State of New Mexico
 Energy, Minerals and Natural Resources

SUNDRY NOTICES AND REPORTS ON WELLS (DO NOT USE THIS FORM FOR PROPOSALS TO DRILL OR TO DEEPEN OR PLUG BACK TO A DIFFERENT RESERVOIR. USE "APPLICATION FOR PERMIT" (FORM C-101) FOR SUCH PROPOSALS.)	
1. Type of Well: Oil Well ☐ Gas Well ☐ Other ☒	
2. Name of Operator OXY USA INC. (16696)	
3. Address of Operator PO BOX 4294, HOUSTON, TX 77210-4294	
4. Well Location	
Unit Letter <u>G</u> : <u>1698</u> feet from the <u>NORTH</u> line and <u>1980</u> feet from the <u>EAST</u> line	
Section <u>5</u> Township <u>18N</u> Range <u>32E</u> NMPM County	
11. Elevation (Show whether DR, RKB, RT, GR, etc.)

OXY USA Inc. - Current/Proposed
Bravo Dome CO2 Gas Unit #51
API No. 30-021-20382

Action 46838

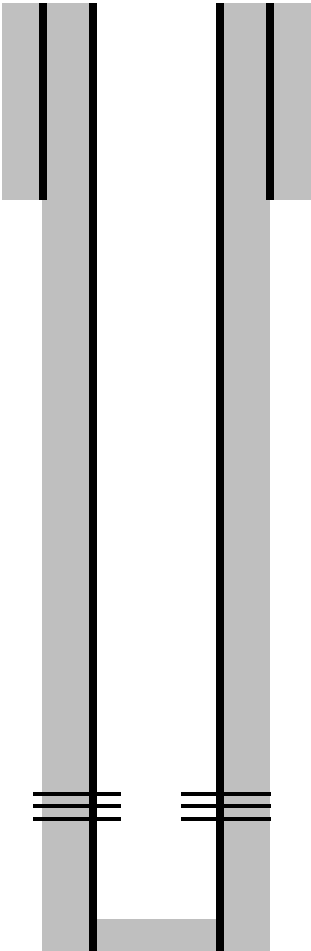
Created By	Condition	Condition Date
mkuehling	NMOCD witness required on all testing. Northwest bradenhead test required prior to MIT - performed day of MIT - all valves need to be dug out and plumbed to surface - do not bury till after testing - chart recorder with 1000 lb spring - 1 hour clock - chart should match spring and clock	9/9/2021
